TCMB – CR-0016

SiD Occupancy Studies for the ILC250 beam parameters

CR-0016 250 GeV Beam Parameters

The SiD Detector Consortium

Pair Background Density in the 5T solenoid field

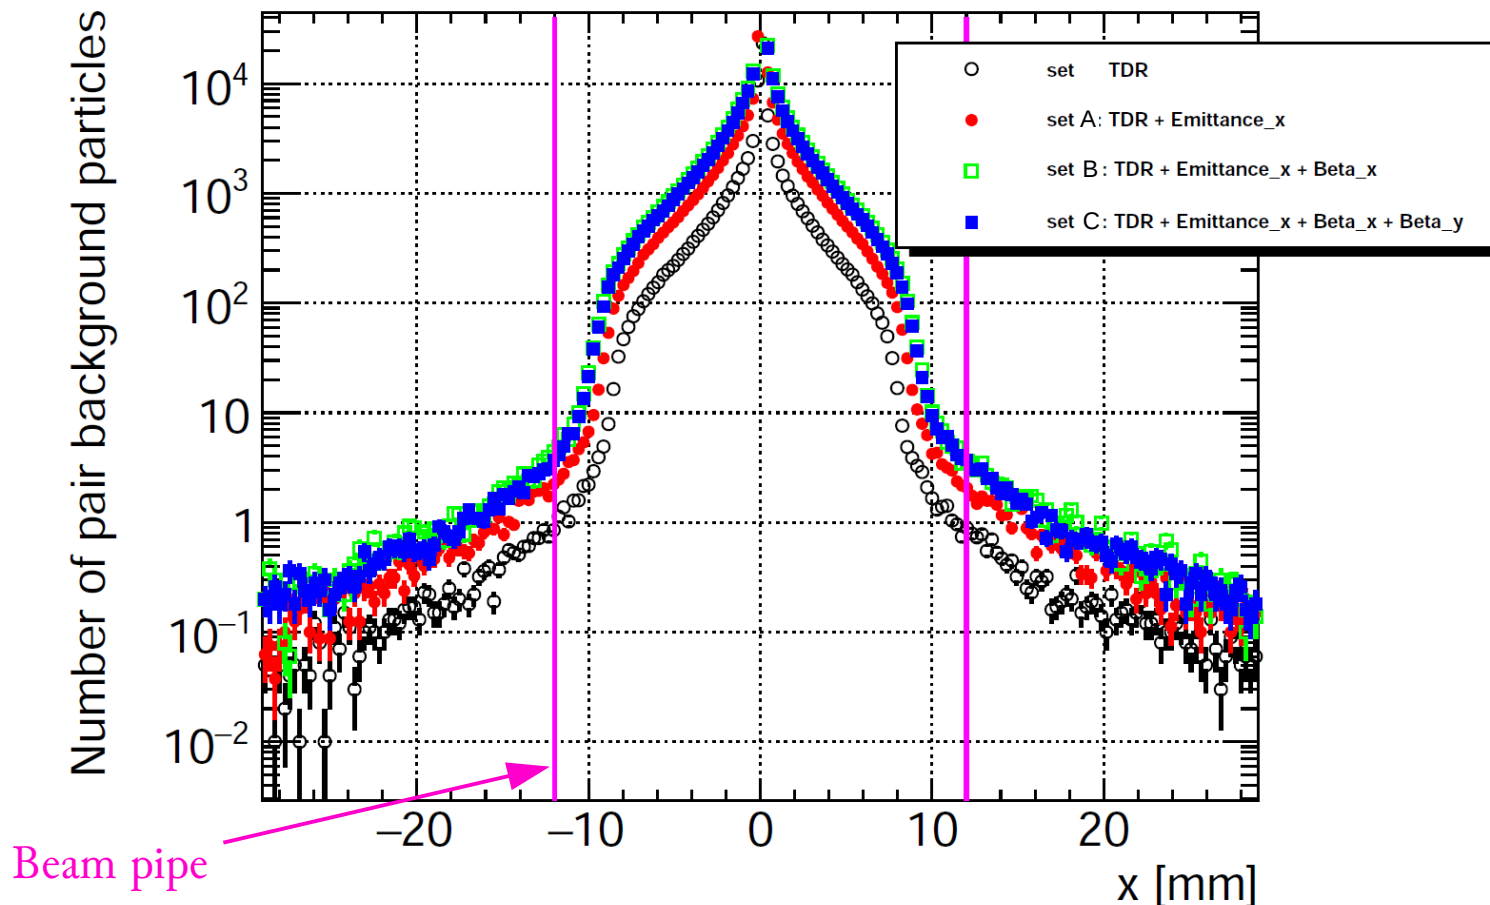
The broader the envelope, the more particles reach the inner most layers of the detector.

The number of pairs is increased by a factor of $\sim 4-6$ wrt the TDR scheme.
The so-called 'pair edge' is well contained within the beam pipe.
Less than 10 particles can be found outside the beam pipe at any given location.

SiD Vertex Detector Occupancy

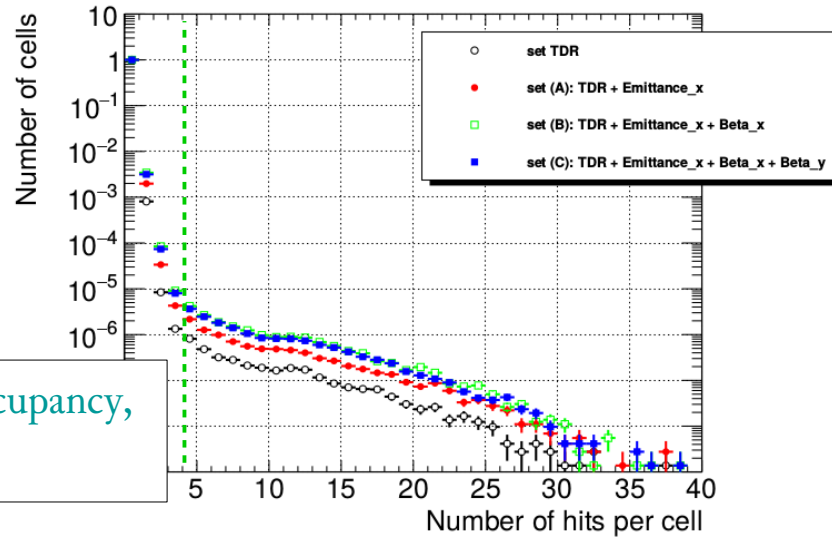
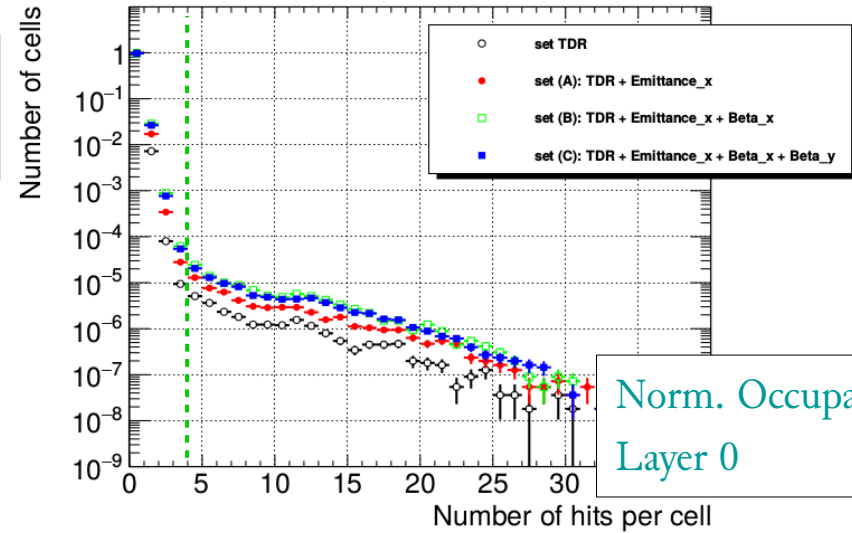
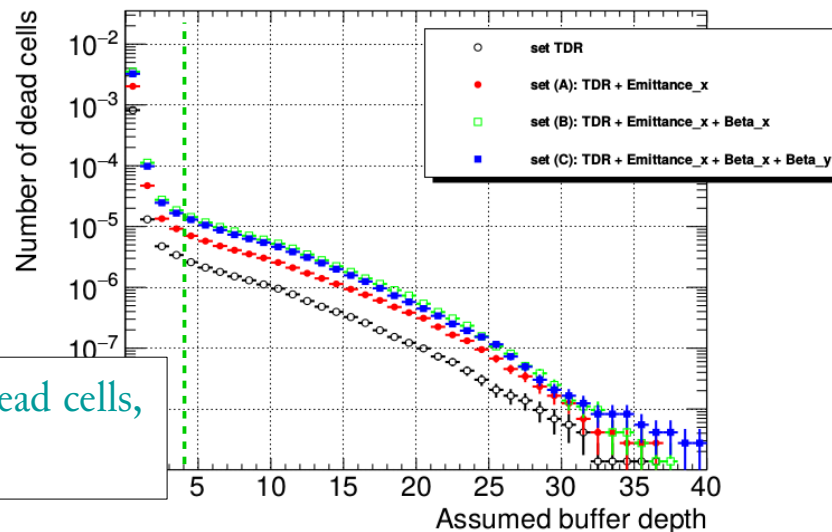
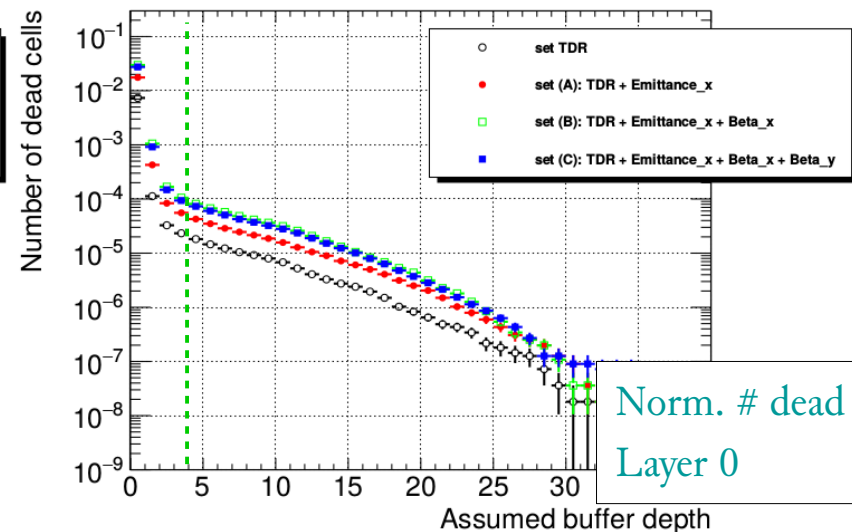
SiD is confident that the occupancy can be accommodated in the design of the pixel detector.
